In the matter of an application for approvals in relation to the Waitaha Hydro Scheme

**EXPERT PANEL: WESTPOWER LTD MEMORANDUM #18  
MEMORANDUM OF COUNSEL COMMENTING ON THE DRAFT CONDITIONS  
OF THE FOUR APPROVALS**

Dated: 27 March 2026

**Figure 1: Hokitika rainfall and minimum temperatures (data from NIWA)**

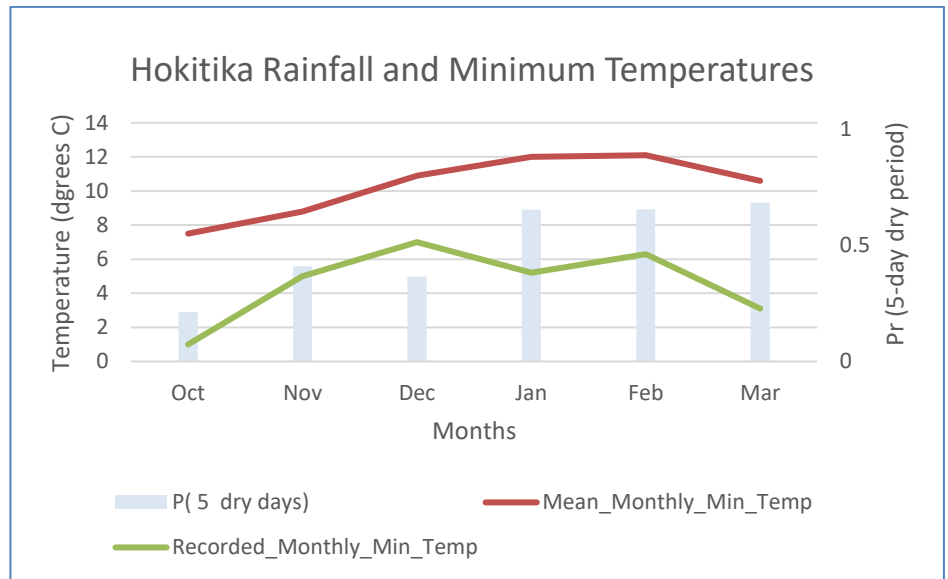
- (iii) The combination of the two. The critical factor is that dry weather and warmer temperatures seldom overlap. The probability of getting a dry five-day period<sup>12</sup> is only above 50% between January and March, and otherwise materially lower as shown in

Figure 1. There are low temperatures below 7 degrees Celsius recorded January to March:

22. To address the Panel's concerns and ensure a proportionate condition that appropriately recognises the potential adverse effects, Westpower requests that Condition **DC54(b)(ii)** is amended as follows:

- (i) the Protocols for minimising the risk of felling occupied bat roosts, Version 4: October 2024 (Bat Roost Protocols) and any other measures to be adopted prior to, during and after bat habitat removal including three minor variations to the Protocol that, if a SQEP (approved bat worker) considers it will not increase the risk of harm to bats in this environment:
  - (1) an approved bat worker will identify low potential bat roost trees between 15 cm dbh and 30 cm dbh taking into consideration knowledge about bat activity and habitat in the area;
  - (2) low risk potential bat roosting trees smaller than 30 cm dbh identified under step (1) can be felled at any time of the year;
  - (3) an approved bat worker can agree to perform acoustic monitoring in weather conditions that differ (but remain appropriate) for it;...
